MFN 06-262
Supplement 4

Subject: **Modified Reactor Building/Fuel Building Truncated Model,
SER-ESB-038 Rev. 5**

**Shimizu Engineering Report SER-ESB-038, Rev. 5,
“Modified RBFB Truncated FE Model Analysis Data,”**

Project	General Electric Company ESBWR Project	Shimizu Document No.	SER-ESB-038
Title	Modified RBFB Truncated FE Model Analysis Data	Rev.	5
		Issued Date	9/22/06
		Revised Date	1/9/07

Figure C-25 Element Forces Comparison NASTRAN to ANSYS (RPV Pedestal: Axial Force [MN/m])

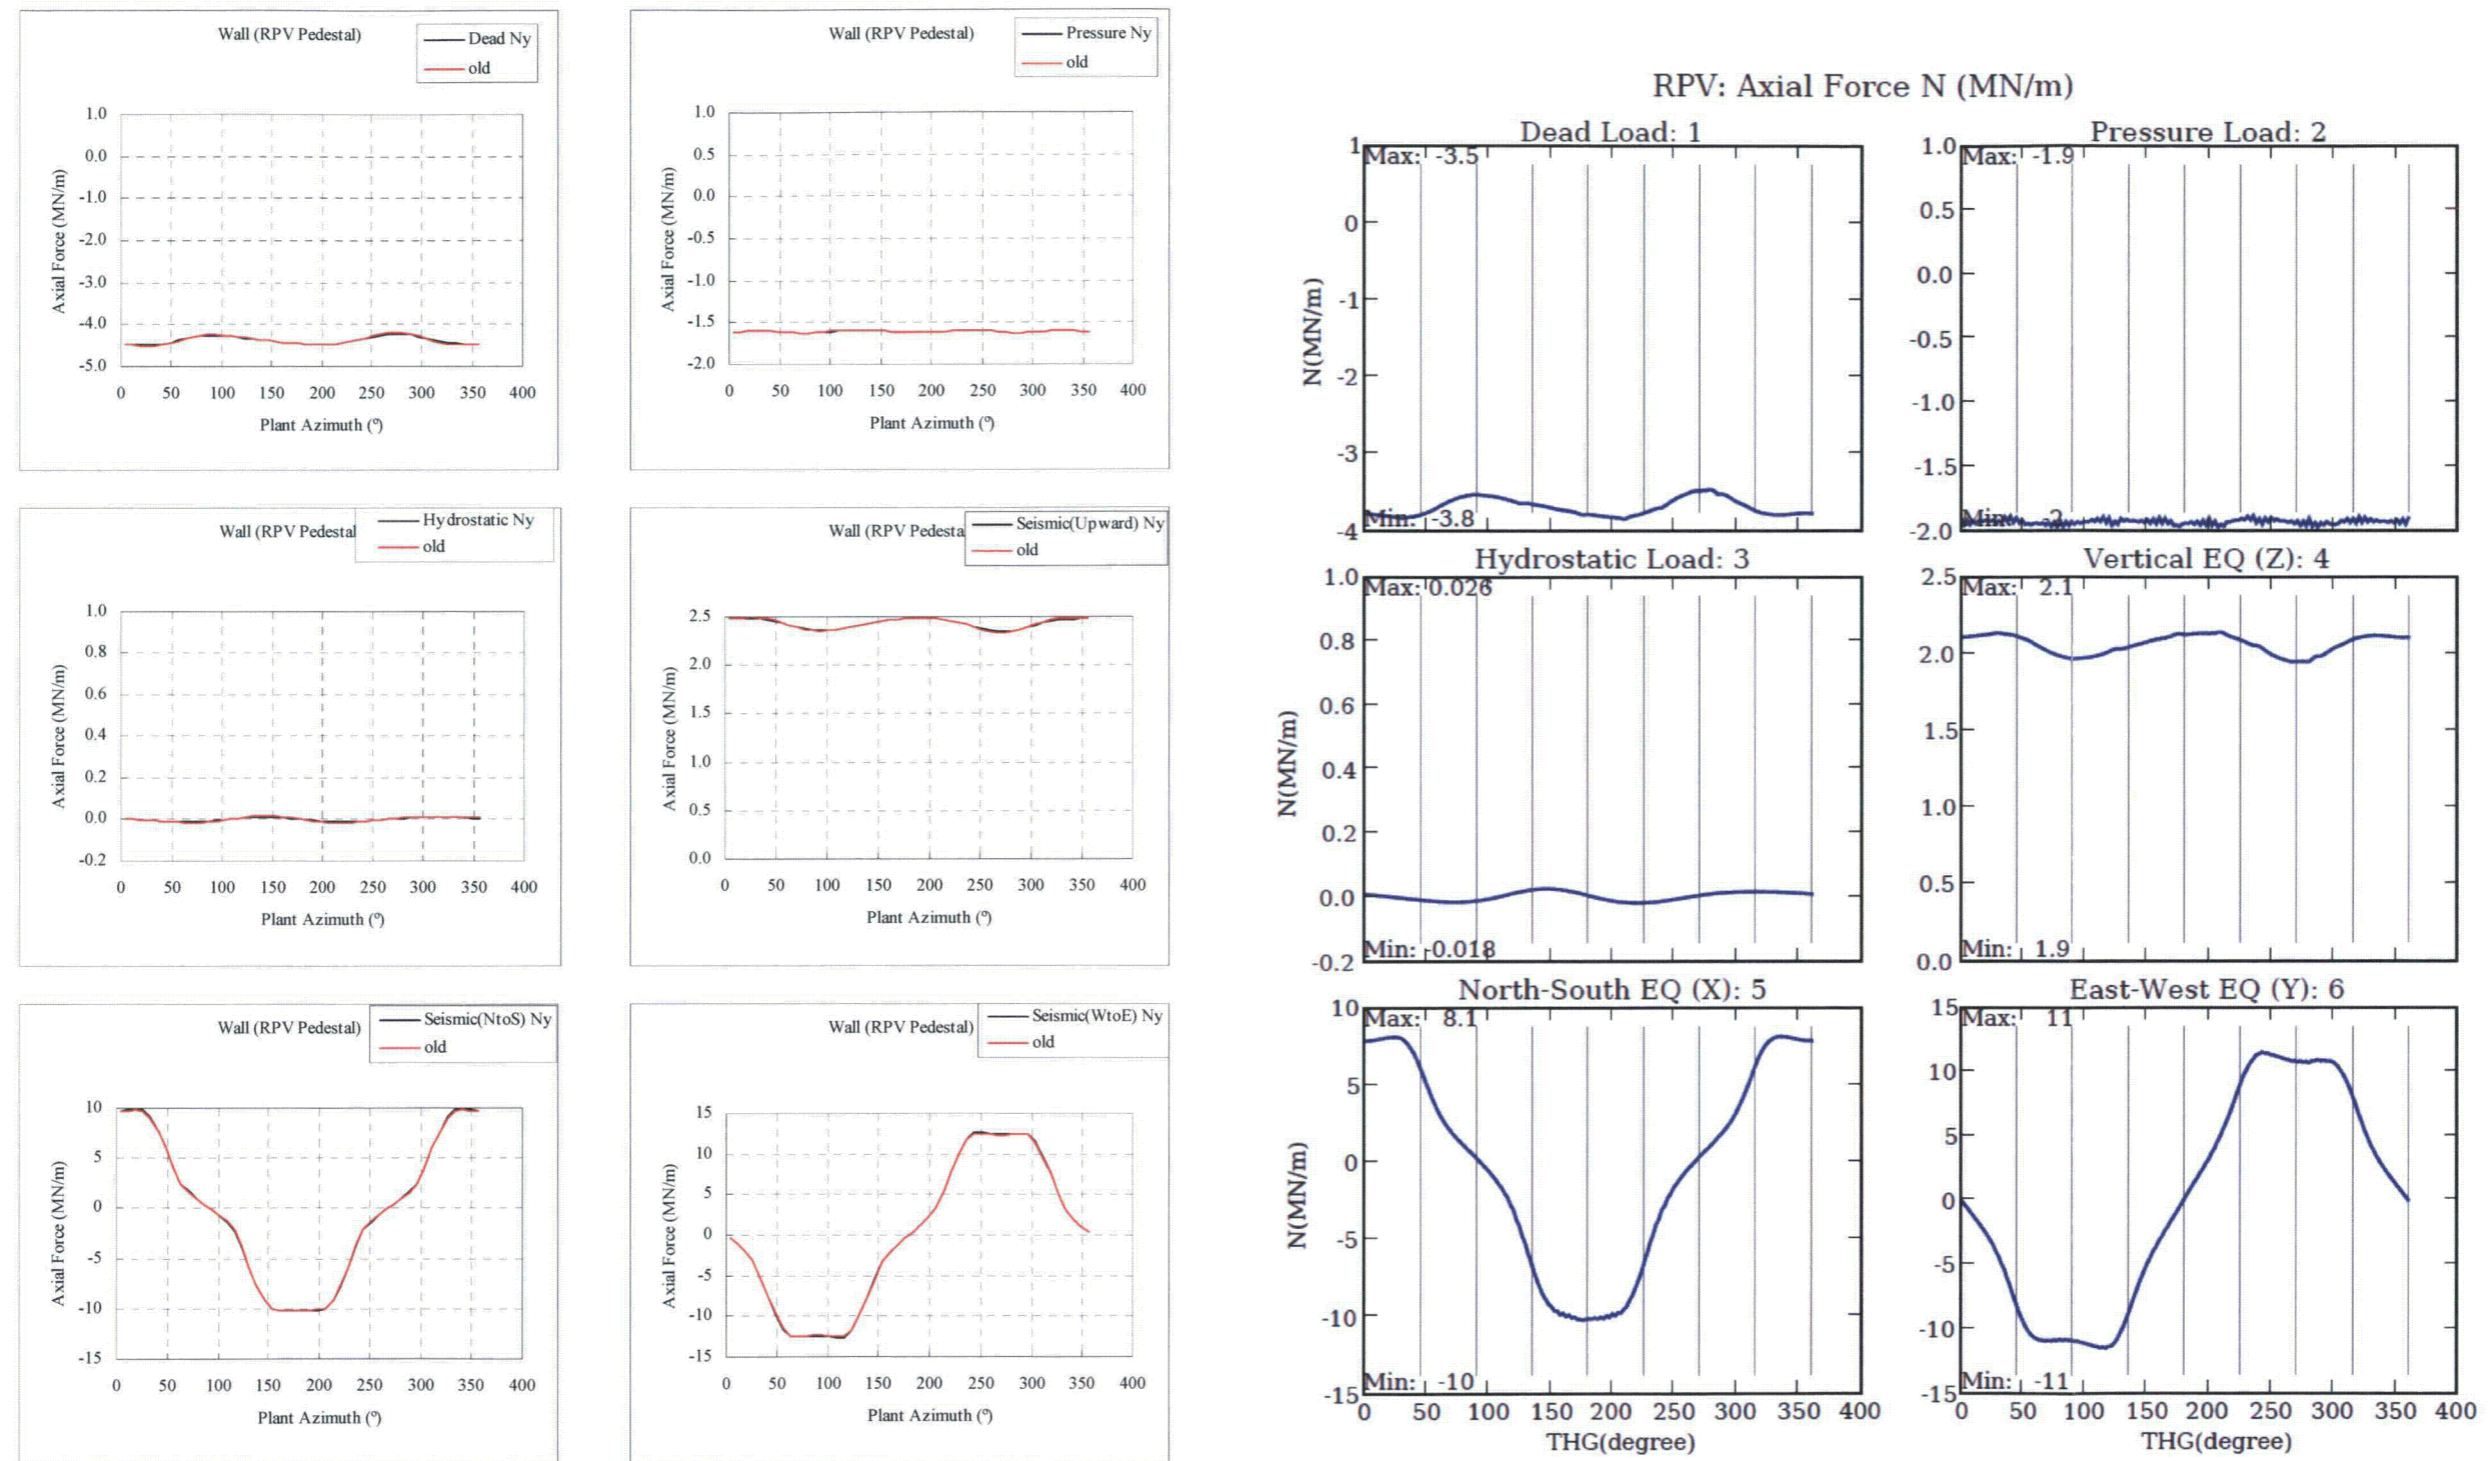
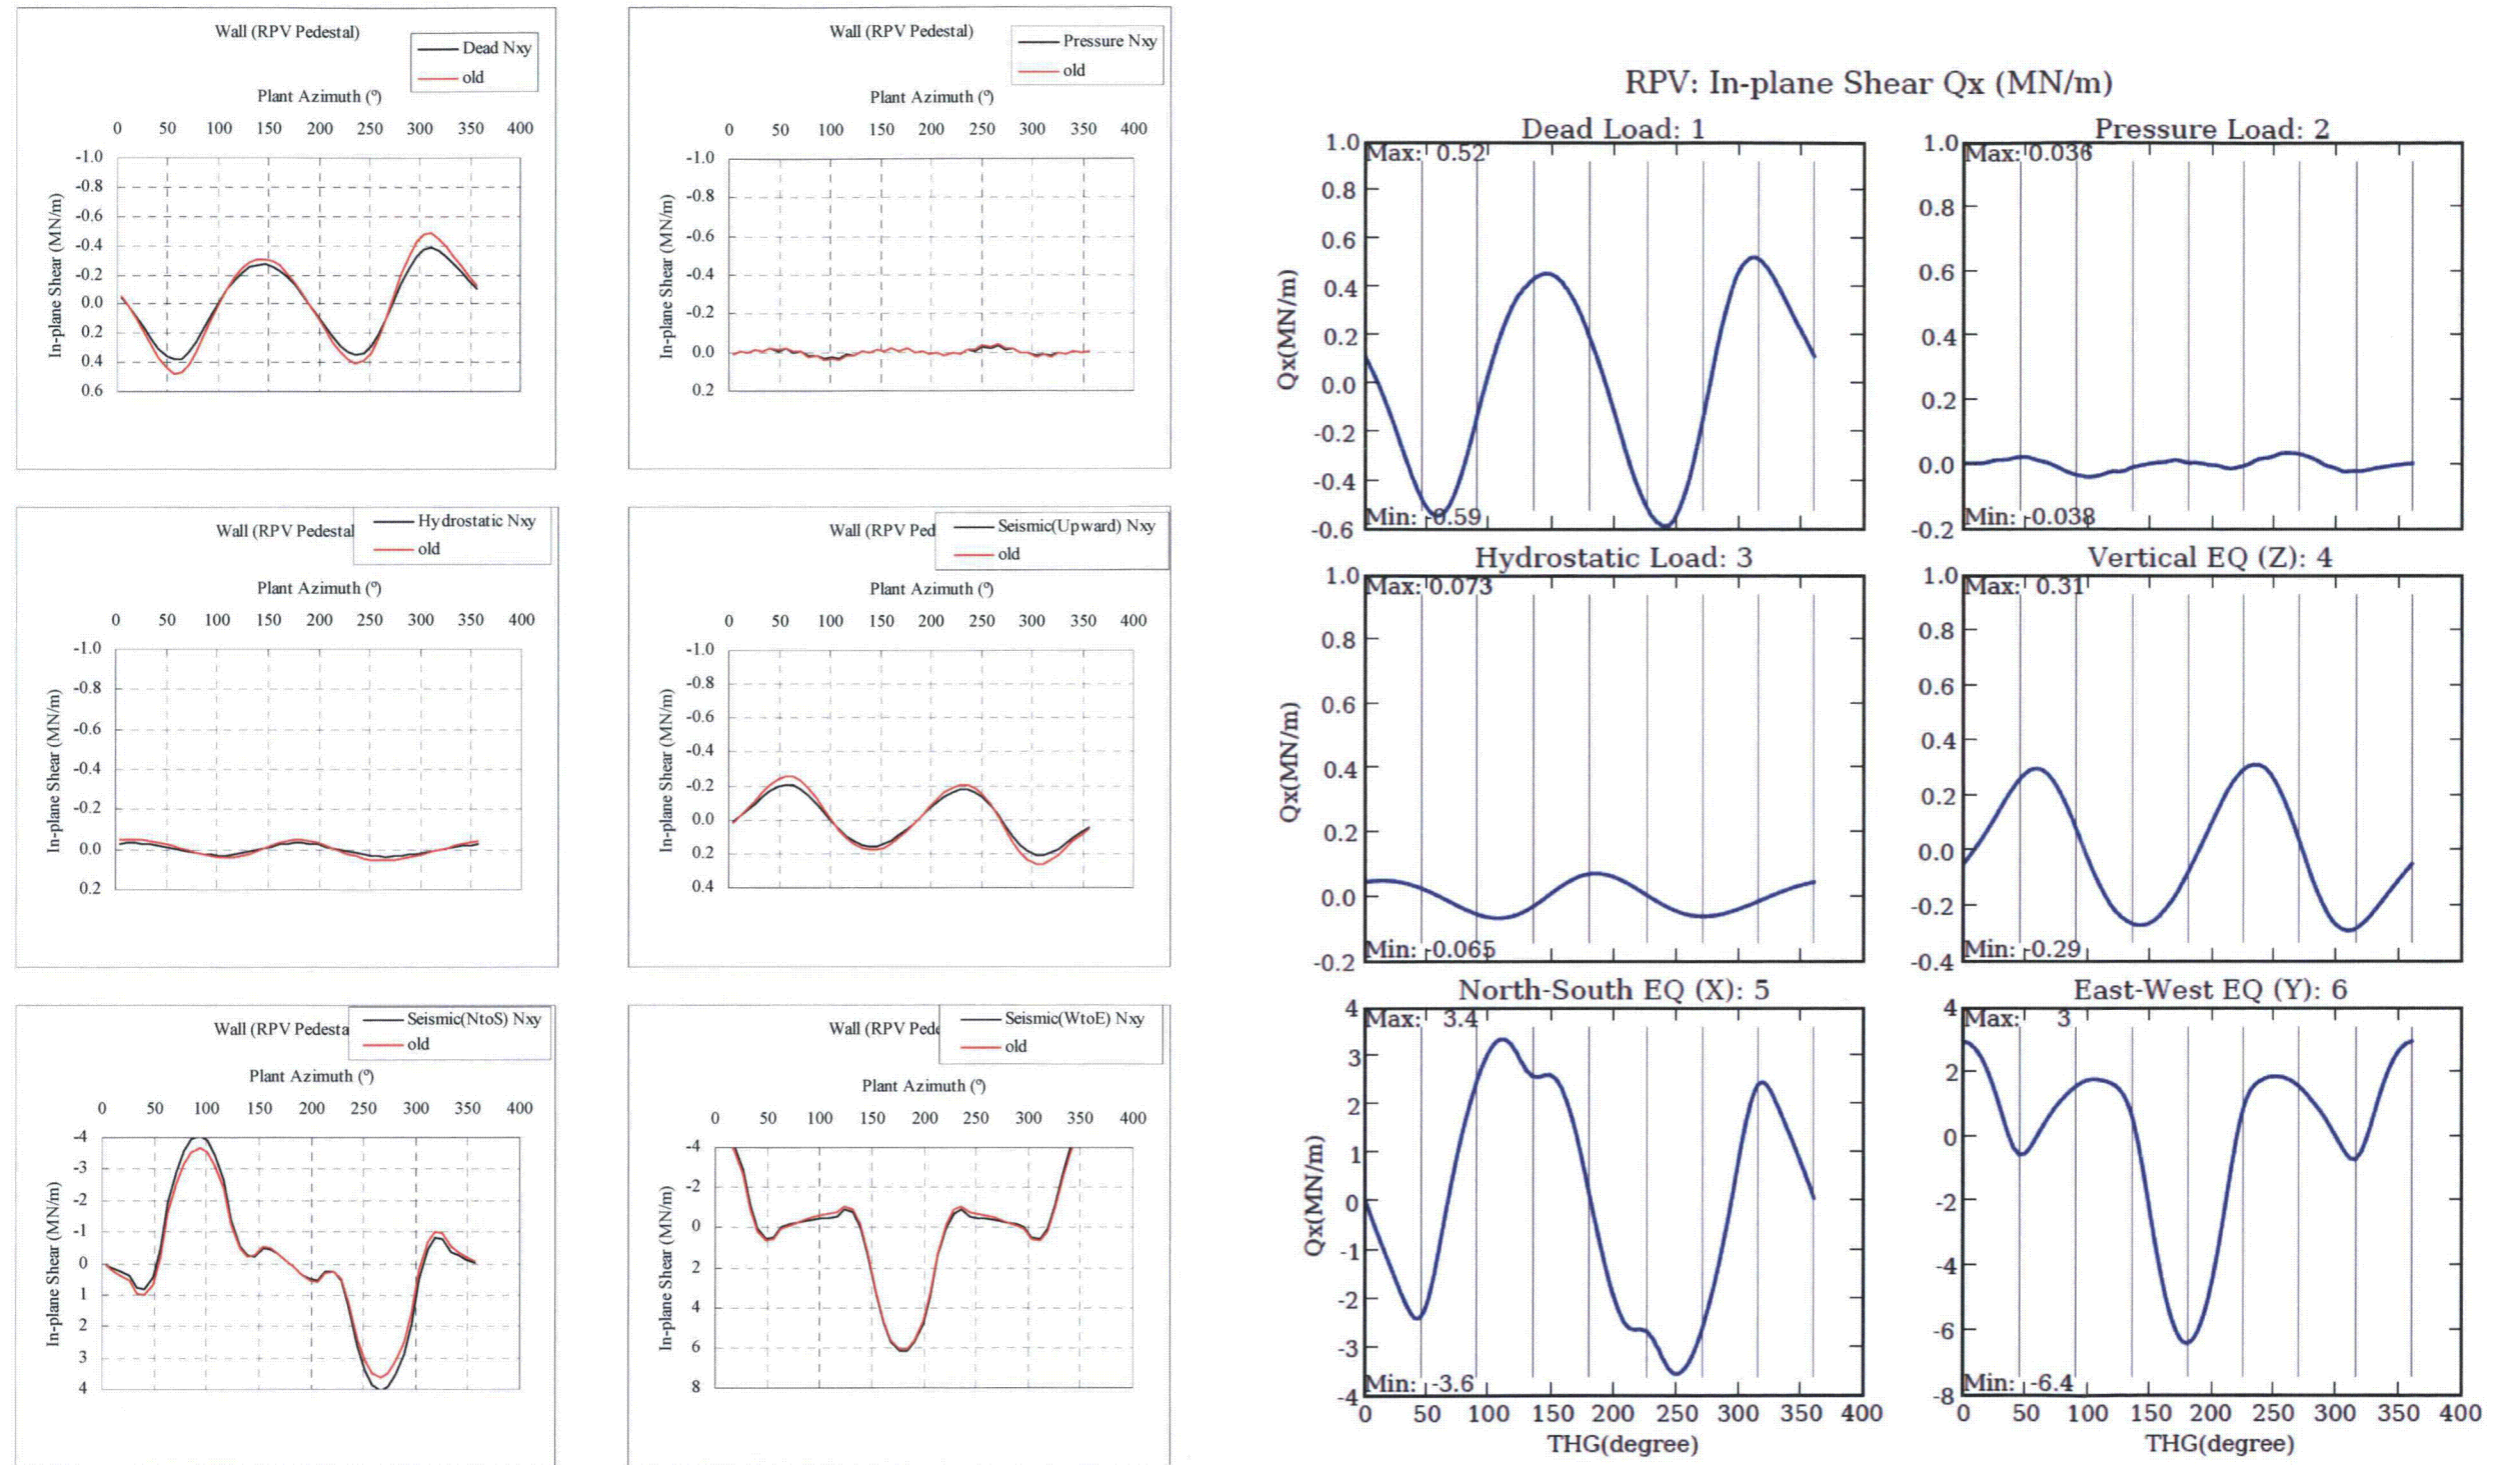
- iii) *The differences of magnitude of forces appeared on basemat inside pedestal:* The result of re-analysis using the updated model shows better agreement. In case of seismic load the magnitude of forces has to be re-compared because BNL's soil spring may not be adequate as pointed out above 3).

- iv) *The differences of magnitude of forces appeared on outer wall of Fuel Storage Pool (FSP):* For the out-of-plane shear forces and moments on RA and F3 wall located around FSP in case of Hydrostatic load, BNL's results are lower than those of GE. GE assumes the some part of differences comes from the difference of estimation levels between both models as pointed out above 8). In order to have a better understanding of the differences, GE would like to request BNL to confirm the input data for Hydrostatic load.
